Submission of Further Information (FI)

Temporary Animal Boarding Establishment with Ancillary Facilities and associated Filling of Land for a period of 5 years in "Agriculture" Zone, Lot Nos. 1493 (Part) and 1500 (Part) in D. D. 107 and Adjoining Government Land, Yuen Long, New Territories (Application No. A/YL-KTN/1177)

Further Information for Planning Application No. A/YL-KTN/1177 Response-to-Comments

Comments from Drainage Services Department

Viewpoint 11

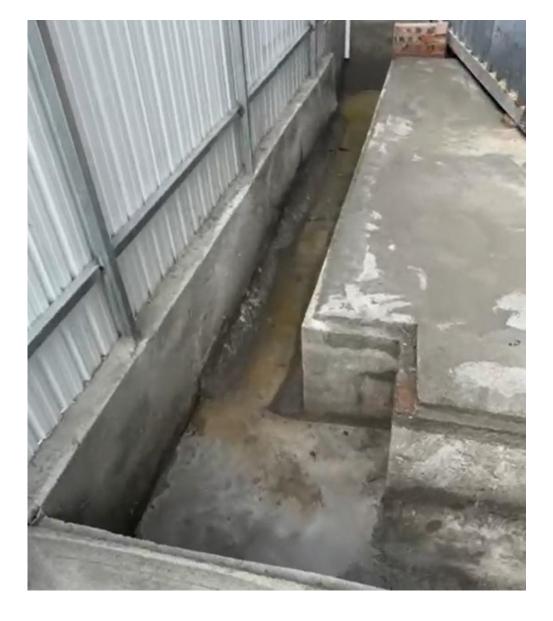
I.	Comments	Responses
1.	Sections - Please indicate the hoarding opening in drawings.	Hoarding with opening is provided at the western side of the site. Please refer to updated Drainage Proposal (Plan 6.1b) for details.
2.	Section B - Please review the adjacent site ground levels. According to our record, the adjacent road level is higher than the application site, external catchment area should be considered. Please update the section and calculations if necessary.	Portion of the adjacent road at the west is at a higher level than the site. External catchment area is included. Please refer to updated Drainage Proposal (Plan 6.1b and Plan 6.2b) and Hydraulic Calculations for details.

The ground level of the Site has been higher than the local track for many years. The surface runoff from the local track will not flow to the Site.
